ADDENDUM NO. 2

POLYTECH HIGH SCHOOL
RENOVATIONS AND ADDITIONS
BID PACKAGE 'A'

This addendum is hereby made part of the Project Manual and Drawings dated 9 July 2012.

CSK039

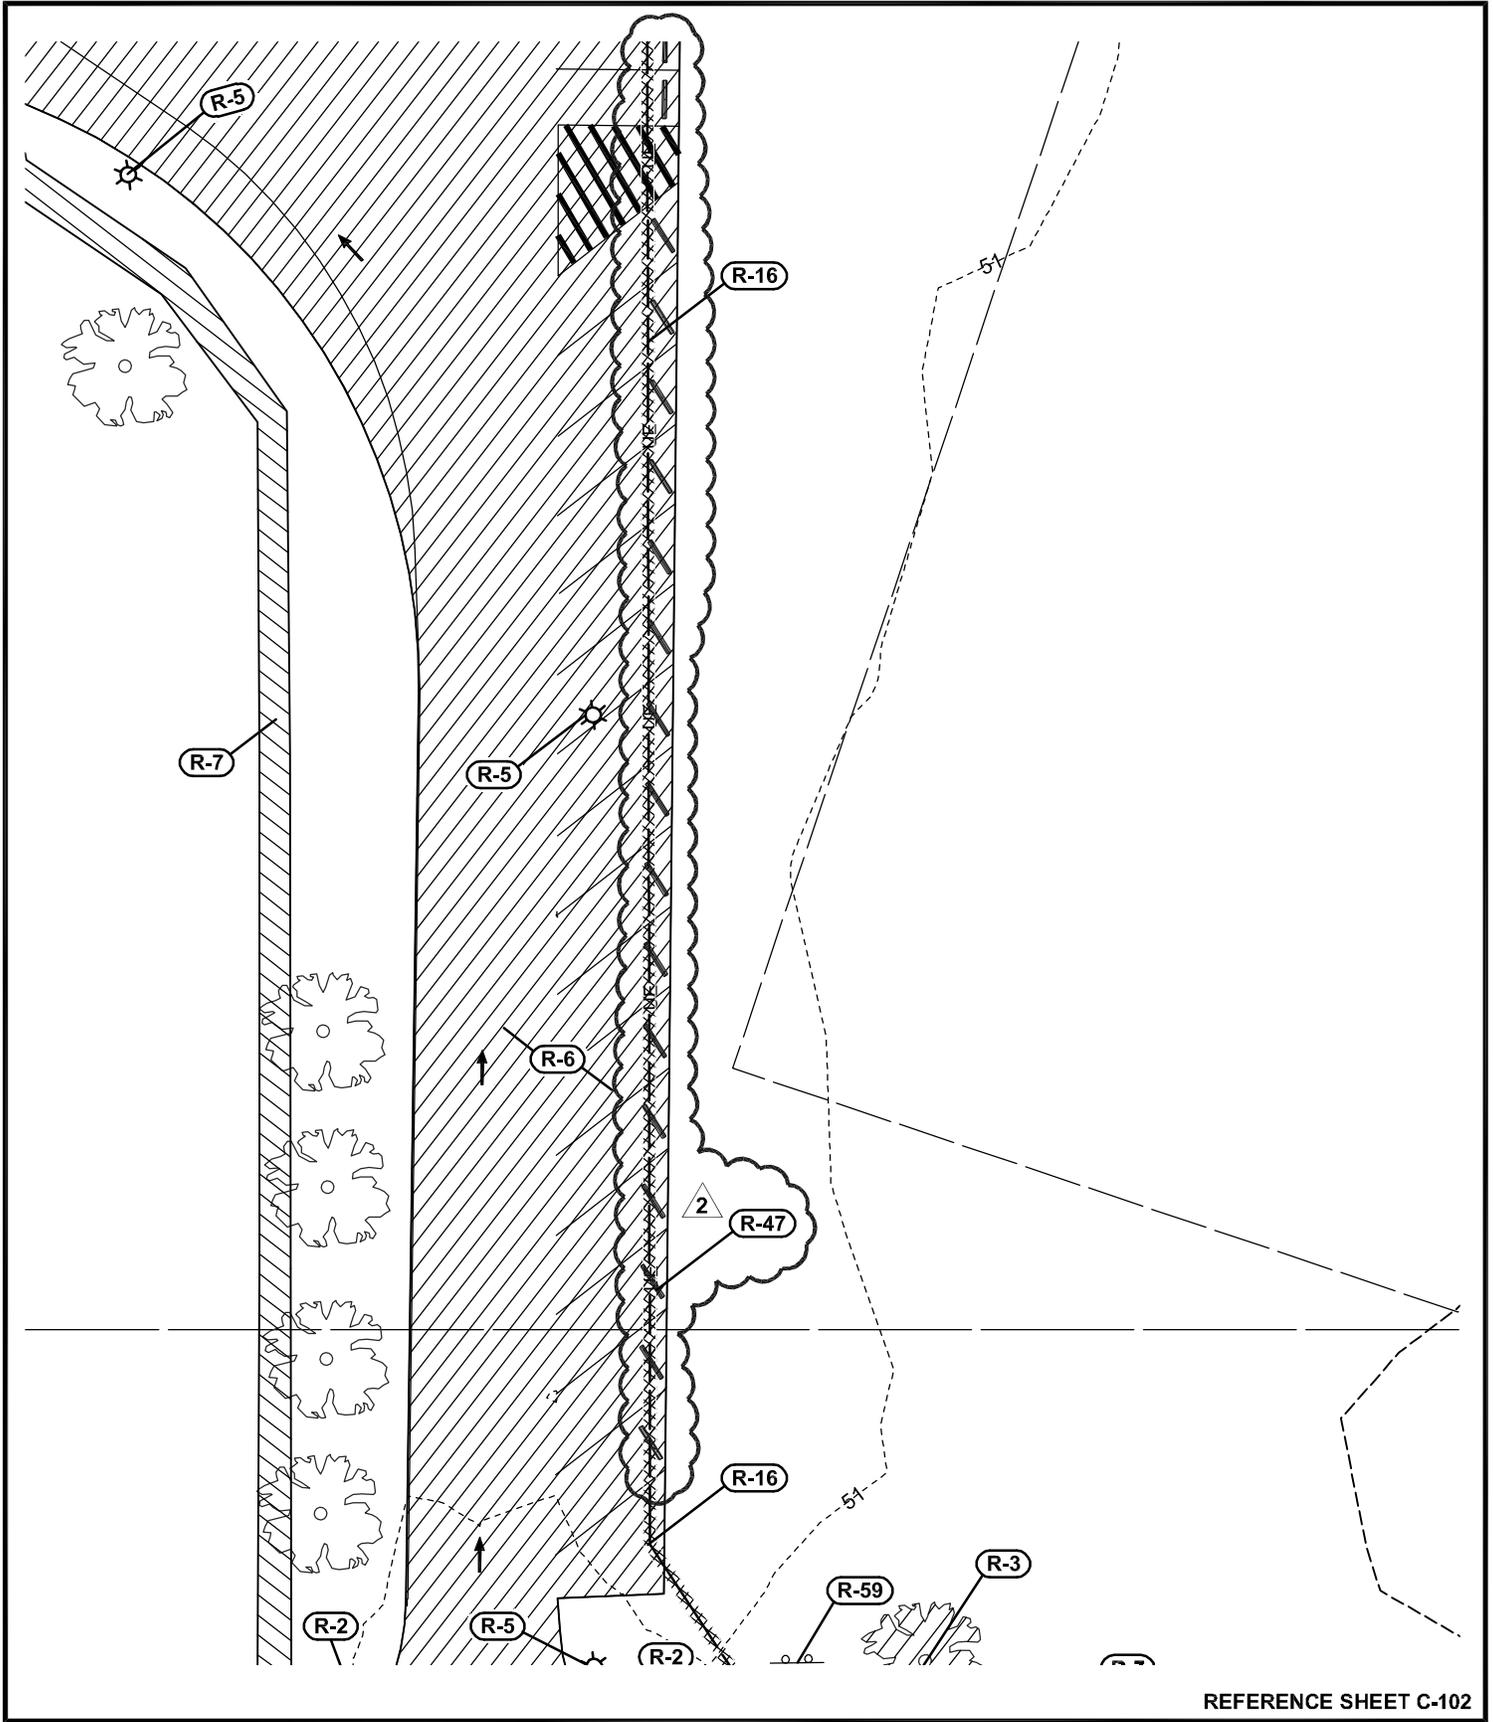
- A. **C-102 Demolition Plan** - Drawing revised as indicated on sketches CSK039, CSK040, CSK041, and CSK042 and included with this addendum.
- B. **C-103 Demolition Plan** - Drawing revised as indicated on sketches CSK043, CSK044, CSK052, CSK053, and CSK054 and included with this addendum.

CSK046

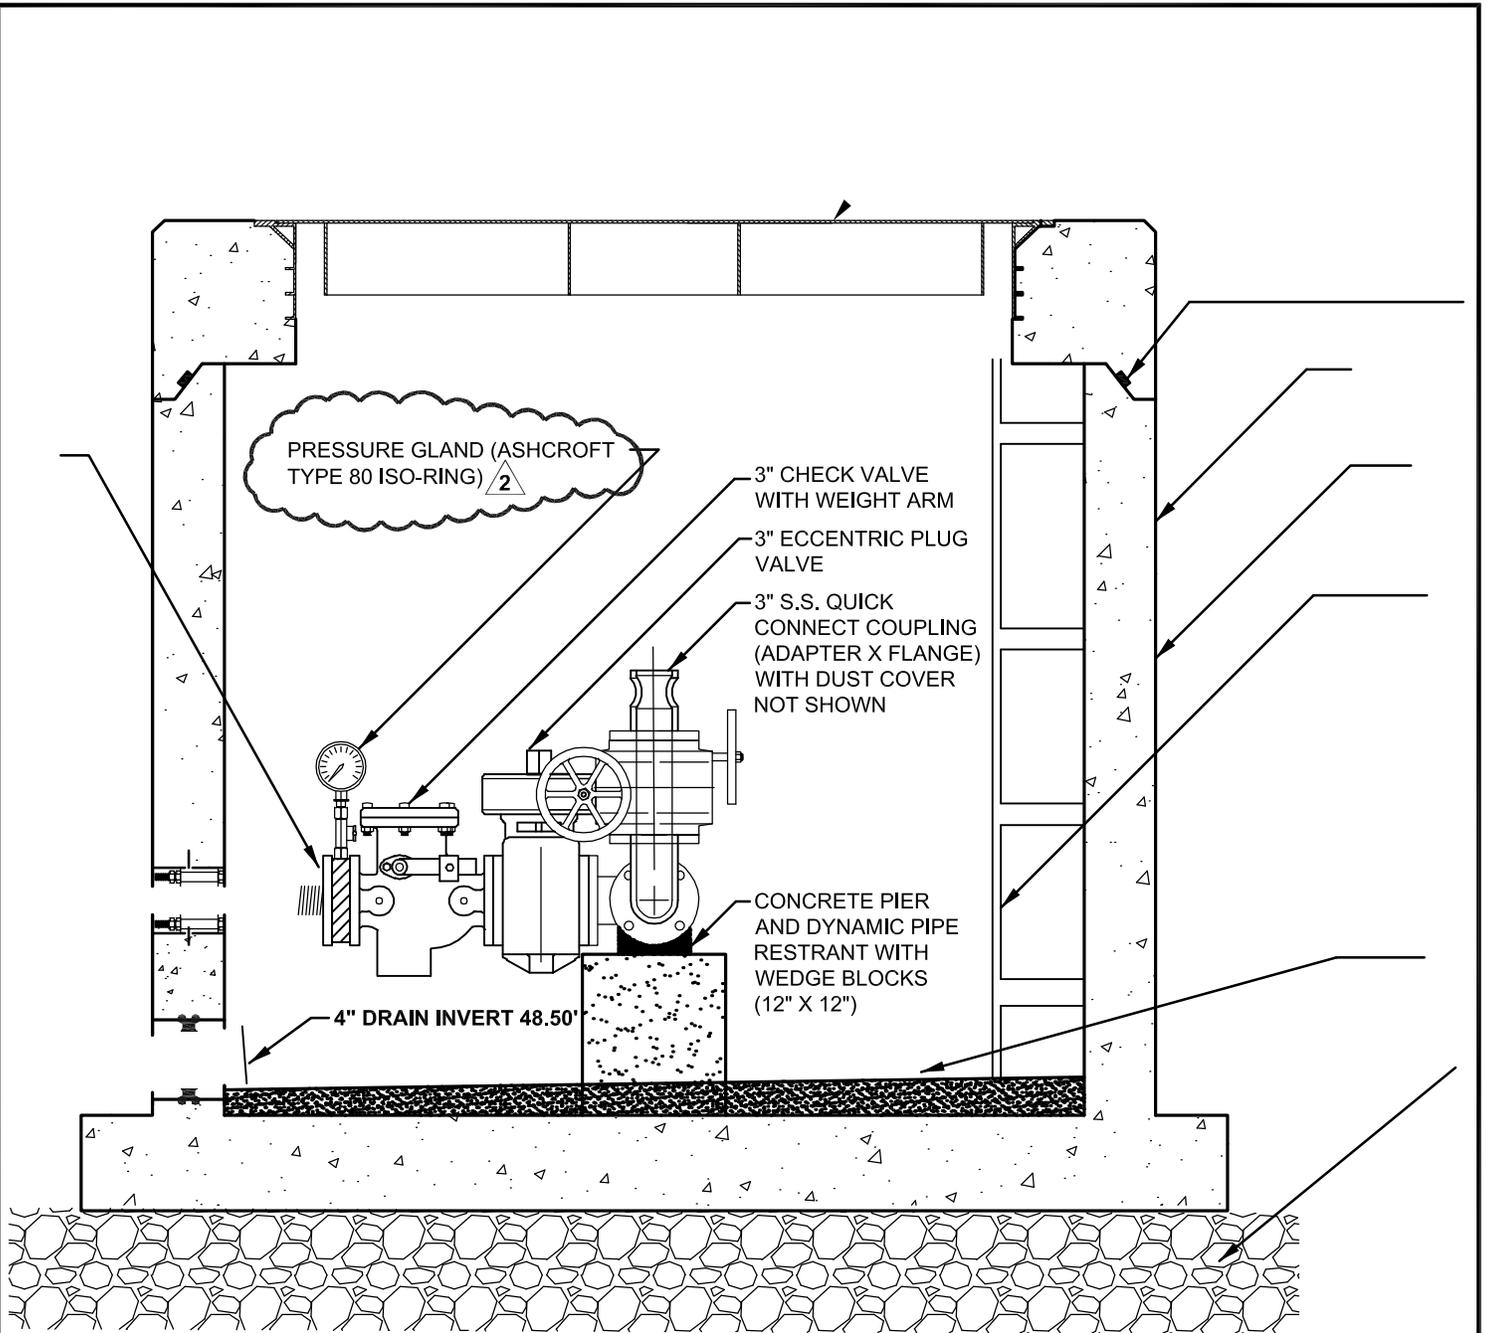
- G. **C-401 Grading Plan** - Drawing revised as indicated on sketches CSK037 and CSK045 and included with this addendum.
- H. **C-402 Grading Plan** - Drawing revised as indicated on sketches CSK038 and CSK046 and included with this addendum.

1. Ref bedding detail shown on plan sheet C-902 for PVC sanitary sewer. Is the granular bedding material the existing trench material or is this off-site material?
2. Ref Type B and Type B modified catch basins which are placed along the ne curb line (CB#10 for example). The typical section for Type B and Type B modified catch basins shows a flat slab top with the frame and grate cast in the top. Does the new curb in this area just sit on top of the slab top?
3. Are the details for the 34" x 24" and 72" x 24" (even though your plans say 74" x 24") to meet DELDOT specs?

1. Granular bedding shall be offsite material.
2. No, the curb sits at edge of slab top.
3. Yes, basins are to meet DelDOT specs. See CSK045 & CSK046 correcting 74"x24" Basin to 72"x24"

CSK048

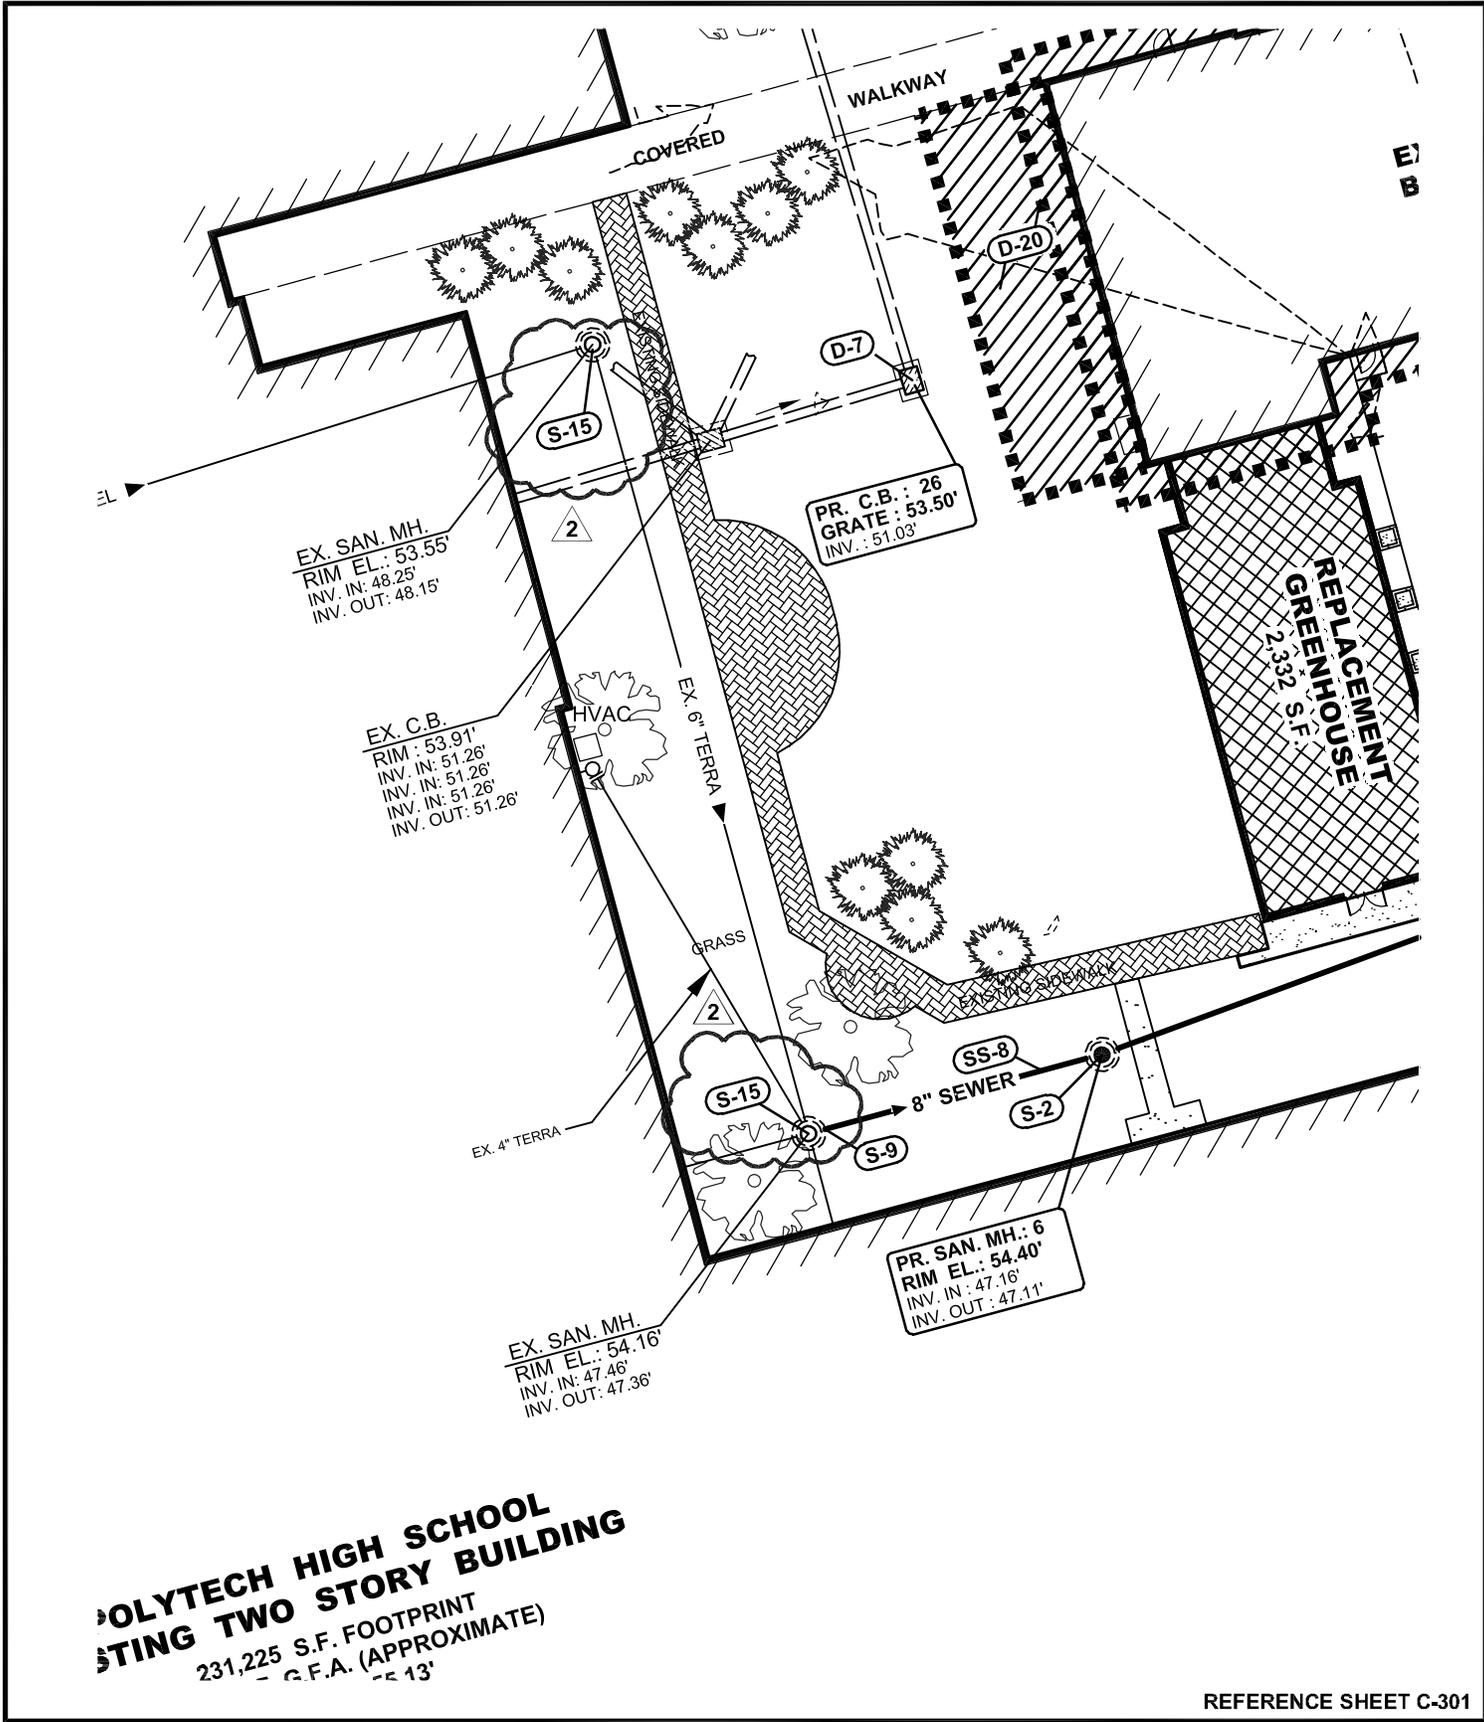
- C. **C-300 Overall Sanitary Sewer Plan** - Drawing revised as indicated on sketch CSK036 and included with this addendum.
- D. **C-301 Utility Plan** - Drawing revised as indicated on sketches CSK048 and CSK049 and included with this addendum.

CSK050

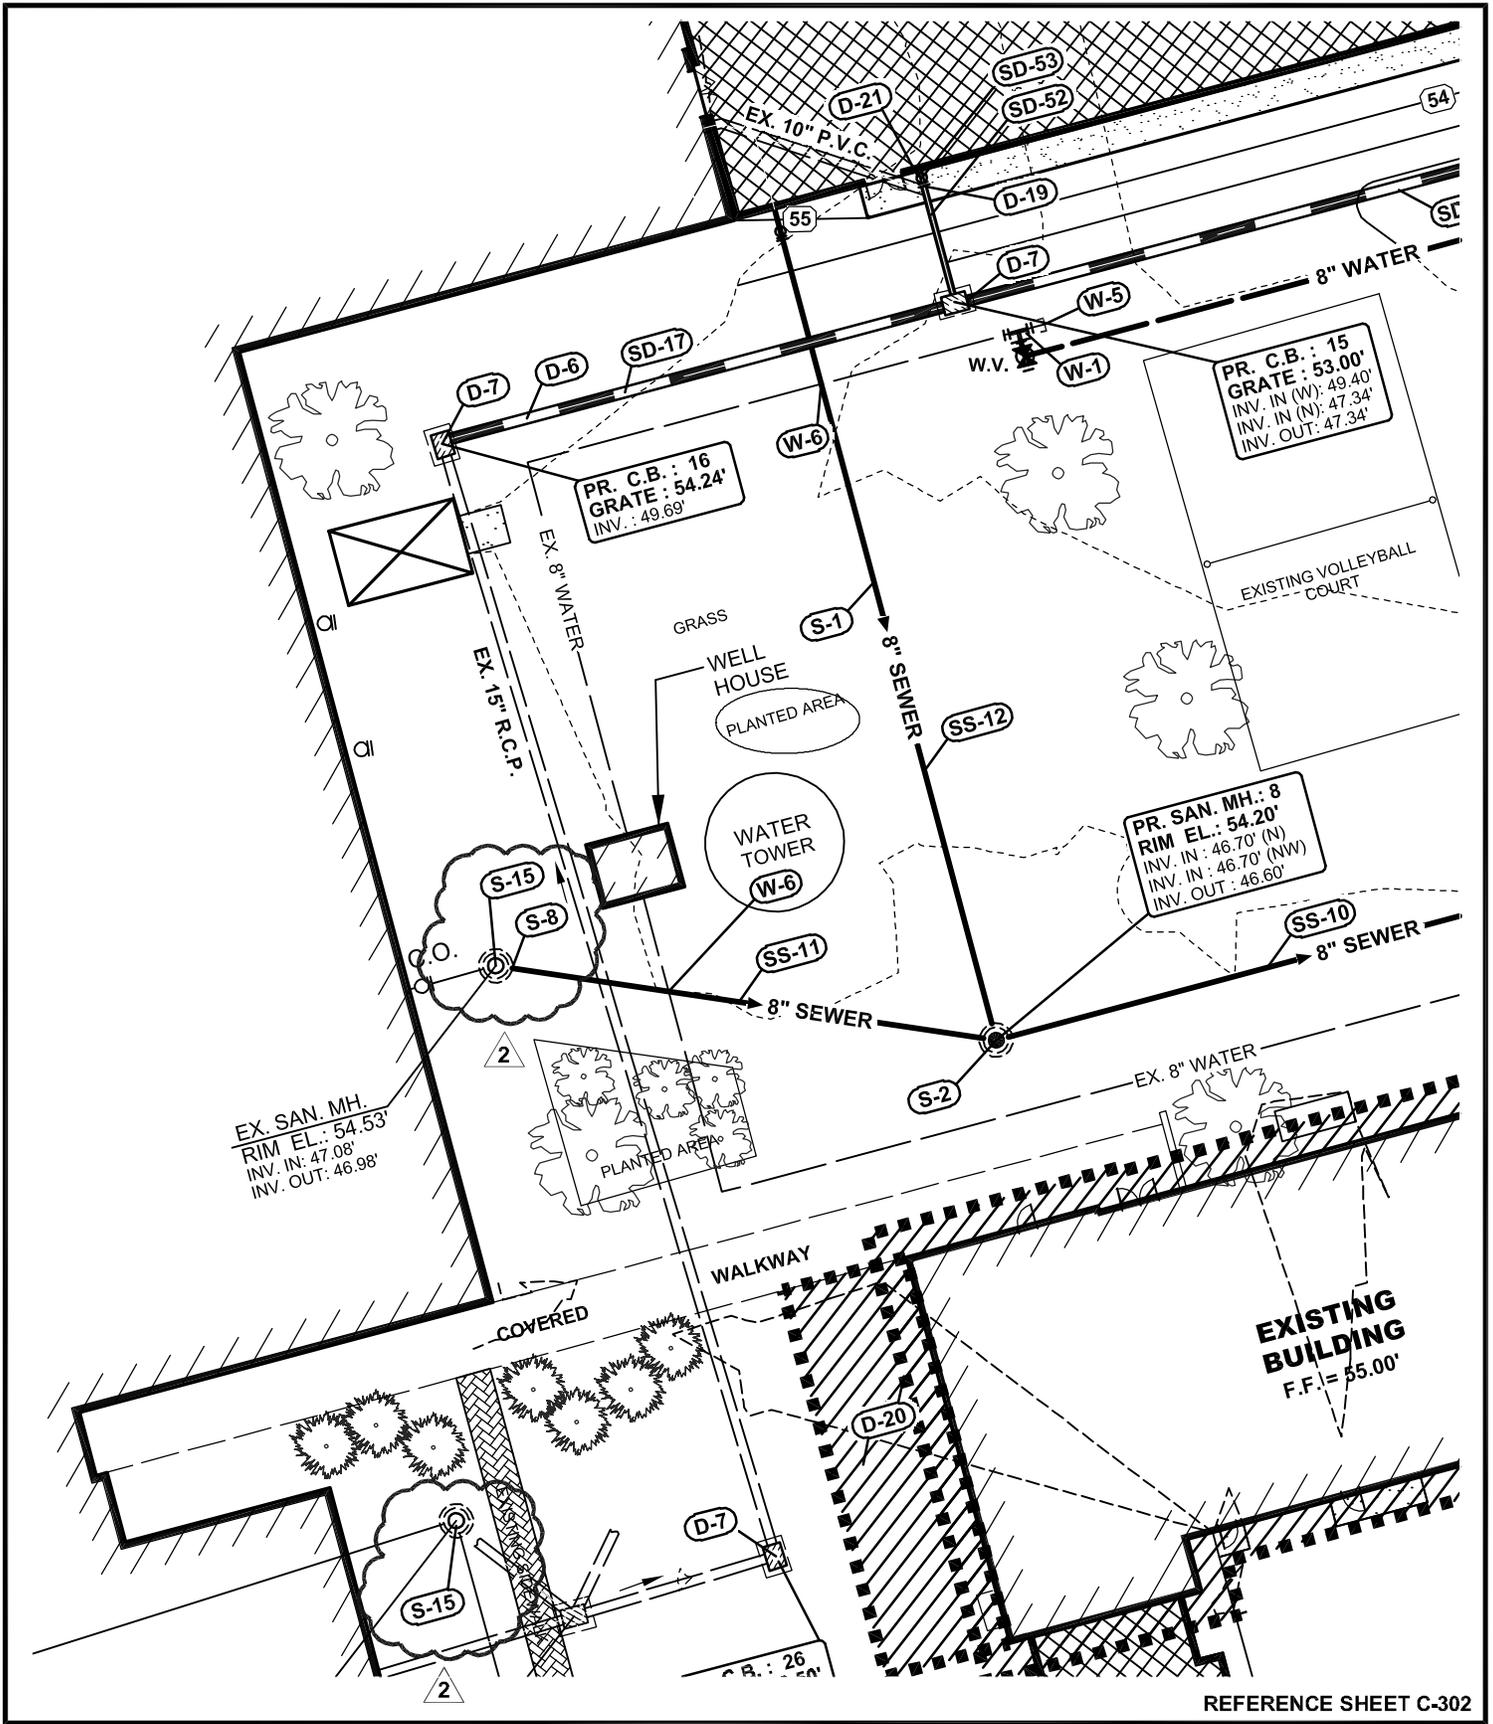
- E. **C-302 Utility Plan** - Drawing revised as indicated on sketches CSK050, CSK051, CSK055, CSK056, and CSK057 and included with this addendum.
- F. **C-303 West Side Pump Station Plans, Sections and Notes** - Drawing revised as indicated on sketch CSK047 and included with this addendum.
